Site Characterization Work
Roads Shop
SECOR JOB 310
Environmental Restoration and Com
August 12,

The following comments are intended to clarify areas of the project, and provide recommendations for site characterization. SECOR may modify these recommendations to improve the quality of the characterization effort.

Project: Duck Valley Investigation Job No.: 31024-001-02
RE: Summary Update

HEATING OIL PIPELINE, WATER WELLS AND
SITE ASSESSMENT, OWYHEE, NEVADA

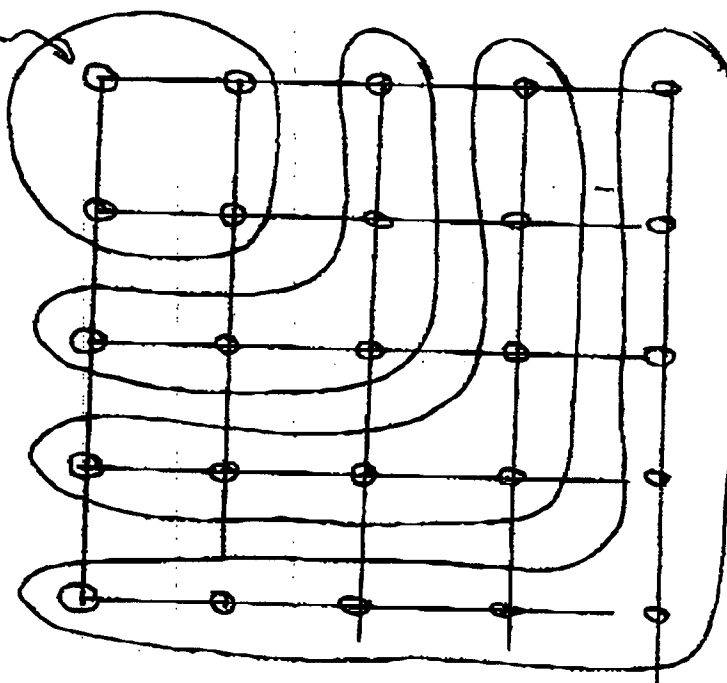
Regarding the methodology for the suspected release areas will a geoprobe be used?

One composite sample will be collected in each bay to include a distance five feet east of each bay.

Suspected areas of release include the third bay, the southwest corner of the Roads Shop Yard, and an area in the vicinity of the water faucet on the north side of Building 323. Sampling and cleanup of the third bay and associated waste pile is discussed in ?????.

Regarding the other two areas, sampling will be collected in a radial manner, starting from the southwest corner of the Roads Shop Yard, and the water faucet and composited (see attached drawing). Samples will be collected every five feet. Four samples will be collected in these two suspected areas of release.

FIGURE 1

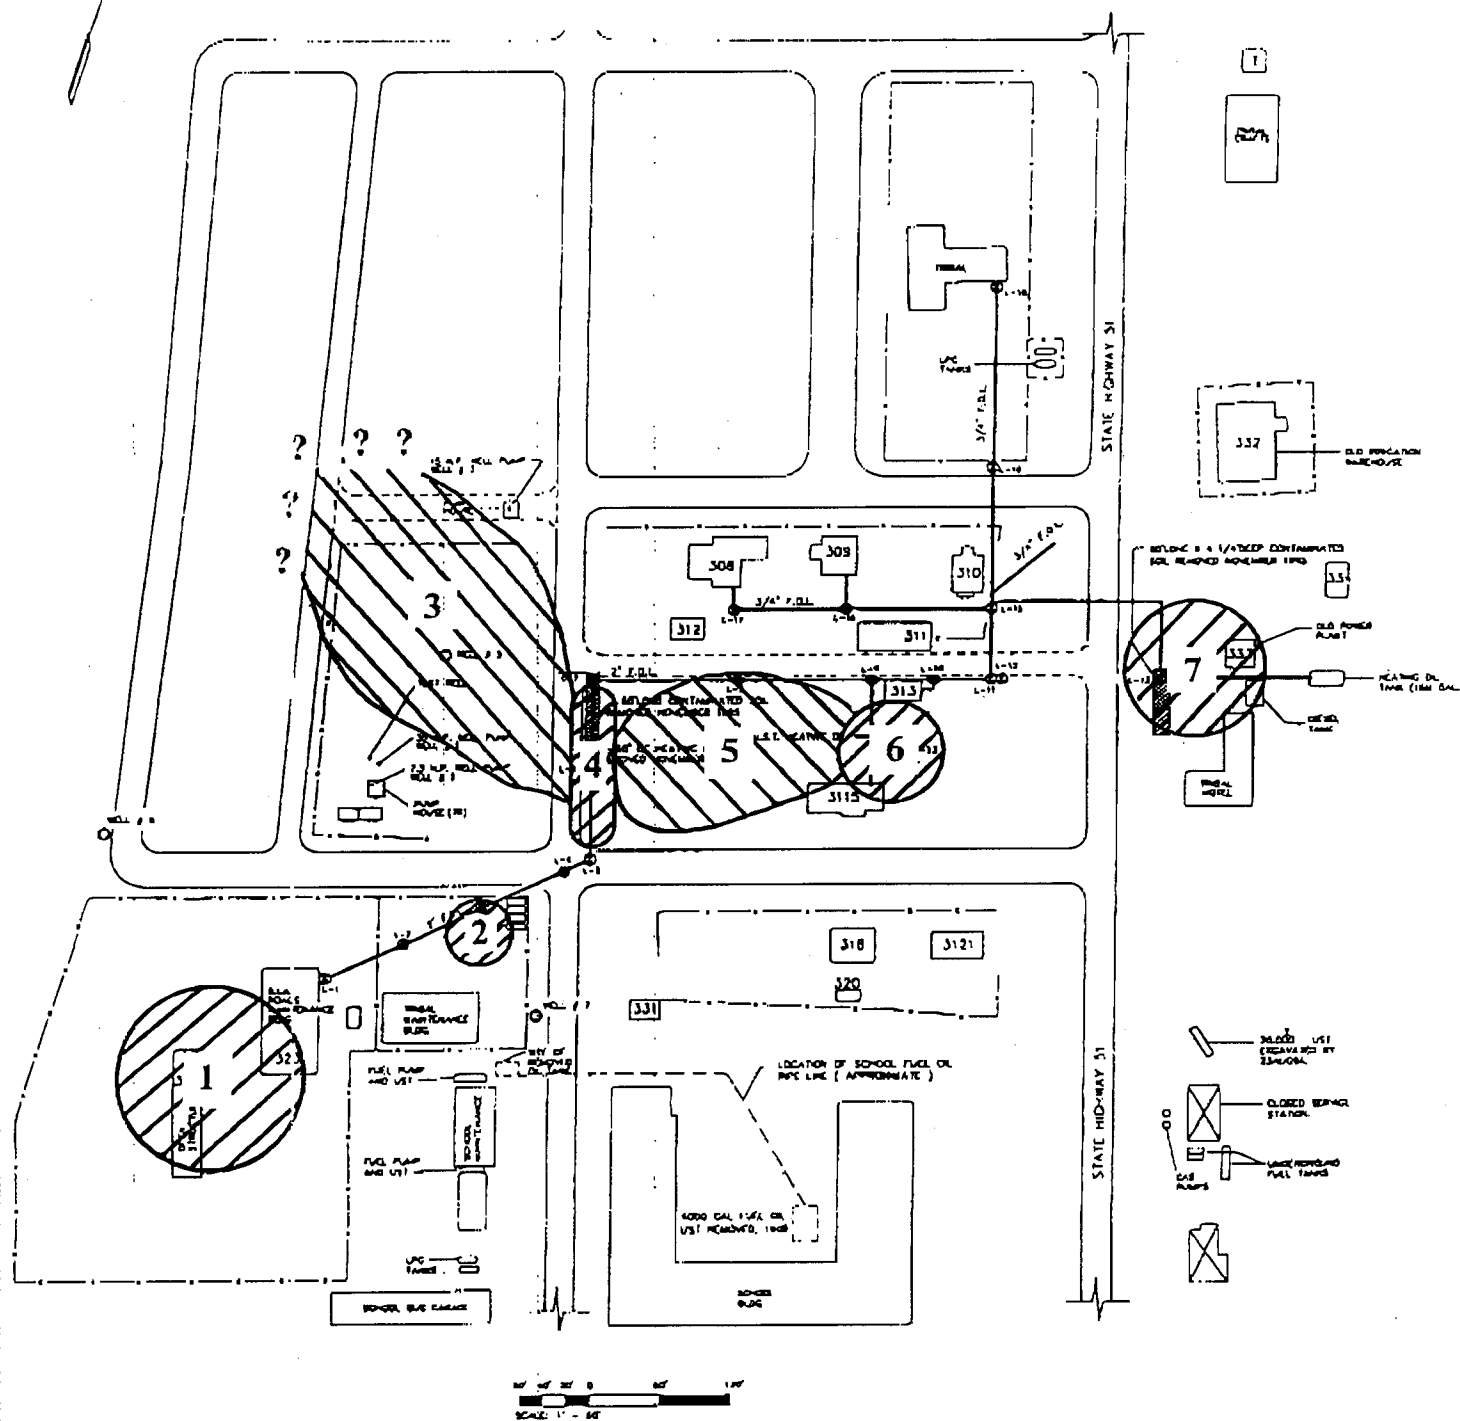
Excavation of soil in the oil leakage areas at the southern end of the yard and the tar spillage areas at the southern end of the open storage structure (Figure 1, #324) has been completed. The impact to soil from leakage or spills in these areas was relatively shallow, and did not exceed one foot in depth below ground surface (bgs). Excavation of soil along the west side of the Road Shop (Figure 1, #323) has been completed. Impact to soil from petroleum hydrocarbons was encountered to a depth of approximately 5-6 feet bgs in this area. Excavation of the discharge pipeline and the soil surrounding the outlet of the discharge pipeline has been completed. No obvious physical impact to soil along the discharge pipe was observed, although a slight petroleum odor was noted at times during the excavation. Impact to soil from the discharge of the pipe in the outlet area was observed to a depth of approximately seven feet bgs. Ground water was encountered at approximately seven feet bgs, but the soil below ground water did not appear to be impacted.

Full completion of excavation activities and characterization of the Road Shop Yard has been curtailed as a result of the discovery of the herbicide dinoseb in bay #3 of the storage structure (#324) and the hazardous waste response activities associated with that discovery. The Road Shop Yard has been quarantined until completion of the hazardous waste response.
